Access Compliance Report Public Rights-of-Way (Curb Ramps)

Main Street: HILLROSE_DR Cross Street: ST_CLOUD_DR Location: SW

ADA ID: RPRK211206145010 Ramp Type: Type 4 - Parallel Initial Pass/Fail: Fail Overall Compliance: No Severity Score: 15

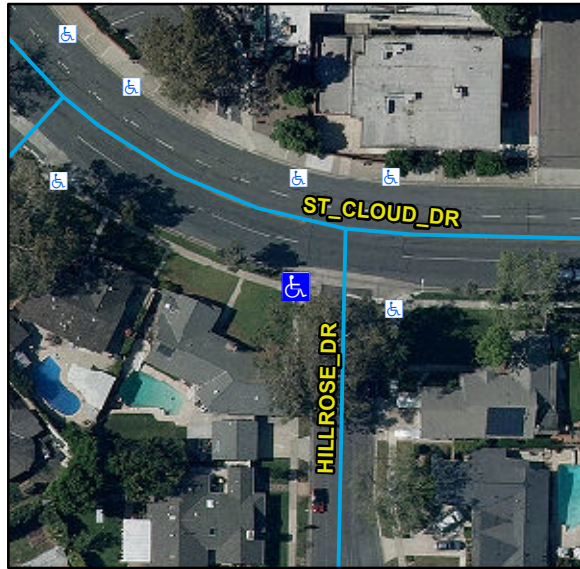
Compliance	Description	Data	Compliance	Description	Data
N/A	Ramp Length LT (in)	115	N/A	Ramp Length RT (in)	114
Yes	Ramp Width LT (in)	108	Yes	Ramp Width RT (in)	108
Yes	Ramp Run Slope LT (%)	6.5	Yes	Ramp Run Slope RT (%)	5
Yes	Ramp Cross Slope LT (%)	1.4	No	Ramp Cross Slope RT (%)	6
N/A	Landing Present	N/A	N/A	DWS Provided	N/A
N/A	Landing Length (in)	N/A	N/A	DWS Contrast	N/A
N/A	Landing Width (in)	N/A	N/A	DWS Length (in)	N/A
N/A	Landing Run Slope (%)	N/A	N/A	DWS Full Width	N/A
N/A	Landing Cross Slope (%)	N/A		DWS Offset Type	N/A
N/A	Landing Movement Obstructed?	N/A	N/A	DWS Offset Left (in)	N/A
	Landing Movement Type	N/A	N/A	DWS Offset Right (in)	N/A
N/A	Landing Shared	N/A			
N/A	Clear Space	Yes			
N/A	Clear Space To Crosswalk (in)	N/A			
N/A	Marked Crosswalk 1	No	N/A	Marked Crosswalk 2	No
	Crossing 1 Direction	E		Crossing 2 Direction	N
	Marked Crosswalk 1 Width (in)	N/A		Marked Crosswalk 2 Width (in)	N/A

Remove & Replace Curb Ramp With Two New Directional Ramps or Equivalent.

R204.3, R304.5.3, STD 1115
